Access Compliance Report

Public Rights-of-Way

Intersection ID: 30431	Main Street: CEDAR_ROCK_DR	Cross Street: ELM_BEND_DR	Location: SE
ADA ID: 8E61623B5DB4	Ramp Type: PerpDiag	Initial Pass/Fail: Fail	Overall Compliance: No
Severity Score: 8.75			
Codes/Mitigation Info/Possible Solution		Field Measurements/Component Compliance

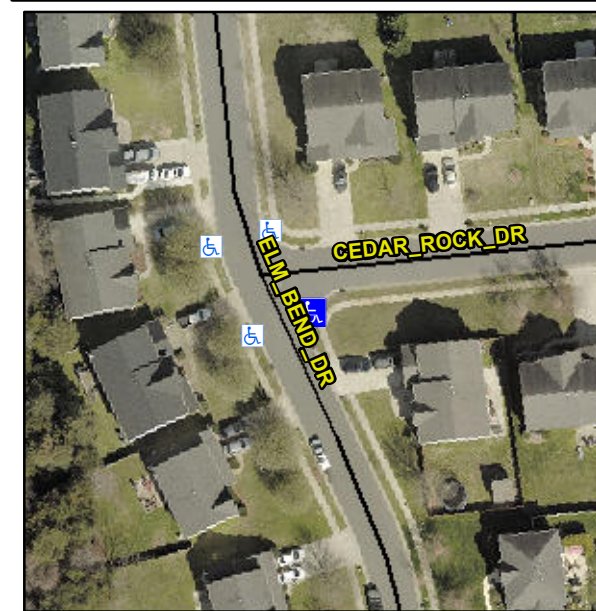
Not Found, R304.5.1

Compliance	Description	Data	Compliance	Description	Data
N/A	Ramp Length (in)	48.0	Yes	Ramp Slope (%)	5.9
No	Ramp Width (in)	43.0	Yes	Ramp XSlope (%)	0.6
N/A	Flare Type LT	N/A	N/A	Flare Type RT	N/A
N/A	Flare Slope LT (%)	N/A	N/A	Flare Slope RT (%)	N/A
N/A	Flare Traversable LT?	N/A	N/A	Flare Traversable RT?	N/A
N/A	Landing Length (in)	N/A	N/A	DWS Provided?	N/A
N/A	Landing Width (in)	N/A	N/A	DWS Contrast?	N/A
N/A	Landing Slope (%)	N/A	N/A	DWS Length (in)	N/A
N/A	Landing X Slope (%)	N/A	N/A	DWS Full Width?	N/A
N/A	Landing Curb? (Y/N)	N/A	N/A	DWS Offset (in)	N/A
N/A	Shared Landing?	N/A			
N/A	Gutter Ponding?	N/A	N/A	Gutter Slope (%)	N/A
N/A	Gutter Lip Ht (in)	N/A	N/A	Gutter X Slope (%)	N/A
N/A	Painted X Walk1?	No	N/A	Painted X Walk2?	No
	X Walk 1 Direction	To NW		X Walk 2 Direction	To SW
N/A	X Walk 1 Width (in)	N/A	N/A	X Walk 2 Width (in)	N/A
	X Walk 1 Slope (%)	1.3		X Walk 2 Slope (%)	1.2
	X Walk 1 X Slope (%)	0.4		X Walk 2 X Slope (%)	0.2

Remove & Replace Curb Ramp With Two New Directional Ramps or Equivalent.
